UNITED STATES PATENT AND TRADEMARK OFFICE

APPLICATION NO.	FIL	ING DATE	FIRST NAMED INVENTOR	ATTORNEY DOCKET NO.	CONFIRMATION NO.
10/625,160	0.	7/23/2003	Yong-Chan Keh	5000-1-397	7995
33942	7590	09/08/2005		EXAMINER	
CHA & REI	•		ROJAS, OMAR R		
PARAMUS,				ART UNIT	PAPER NUMBER
				2874	<u></u> _

DETAILED ACTION

Claim Rejections - 35 USC § 103

Figure 1 of Ohta.

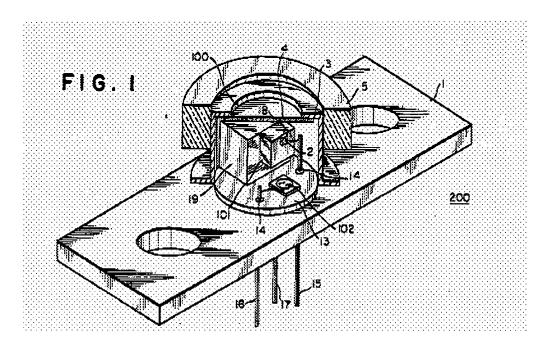
Regarding claim 1, Ohta discloses an optical module comprising:

- a stem (1 and/or 13);
- a silicon optical bench (101) disposed on the stem,
- a laser diode (2) disposed in/on the silicon bench (101);
- a photo diode (102) disposed in/on the stem, the photo diode (102) converts light received from the laser diode into current (col. 4, lines 25-30);
- and a plurality of leads (15-17) coupled to the stem. See Figure 1 of Ohta reproduced below.

Thus, Ohta only differs from claim 1 in that Ohta does not teach:

- The laser diode disposed over a V-groove and
- the photodiode monitors photo-current level using light reflected from the V-groove.

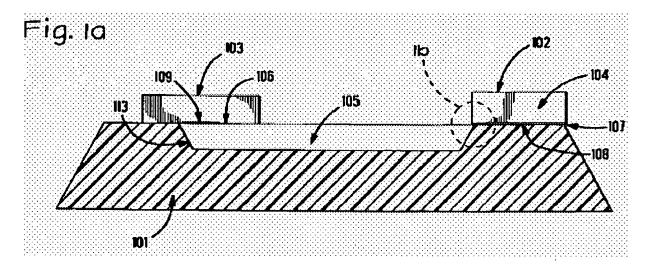
Boudreau, however, teaches both of these limitations. As seen in Figure 1a of Boudreau, a laser diode 102 is disposed over a V-groove 105 and a photodiode 103 monitors photo-current level using light reflected from the V-groove. See Boudreau at col. 2, lines 15-27. Figure 1a of Boudreau is reproduced below.

The advantage of Boudreau is in having "a monitor-detector and laser subassembly ready for mounting in an optical assembly having been burn-in tested thereby increasing production yield." Boudreau at col. 1, lines 58-62.

Regarding claim 5, Ohta further differs in that Ohta does not teach bonding his photodiode (102) to the same silicon bench (101) as the laser diode. Boudreau, on the other hand, also teaches these features (see Figure 1a, above). Thus, when Boudreau is combined with Ohta, claim 5 is also considered obvious for the same reasons mentioned with respect to claim 1.

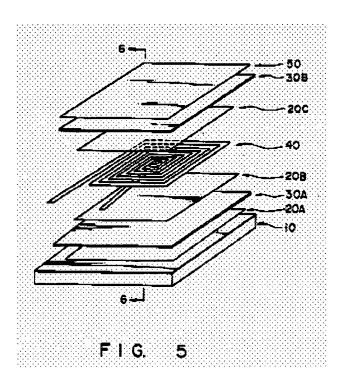
Mizoguchi, however, teaches a spiral type thin film inductor choke coil (40) disposed on a silicon substrate (10). See Figure 5 of Mizoguchi reproduced below.

The inductor coil (40) of Mizoguchi is desirable to use as a DC-DC power converter and for miniaturization of electronic devices. See Mizoguchi at column 5, lines 47-52 and column 6, lines 23-27.
